Friends of Moonee Ponds Creek Inc

23 June, 2024

SUBMISSION - DRAFT CHELMSFORD STREET, KENSINGTON OPEN SPACE

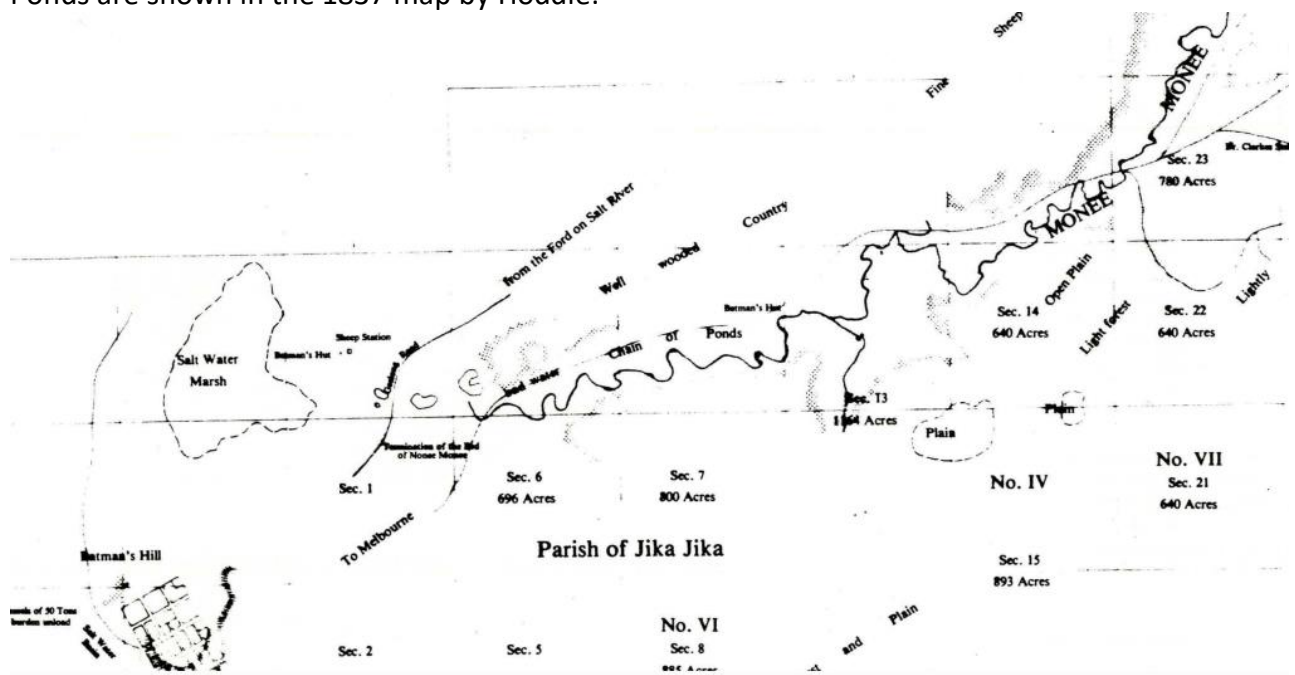
Concern is expressed that the proposed rectangular lawn area could become a 'de facto' dog park and the ground surface polluted. This should be a dog-free area.

The proposed prominent location of the toilet block in the concept plan is opposed! And someone thought placing a gathering space behind the toilet block was a good idea??!! The toilet block should be placed against the retained western warehouse wall, closer to the BBQ area. Building it from reused warehouse bricks would make it blend in.
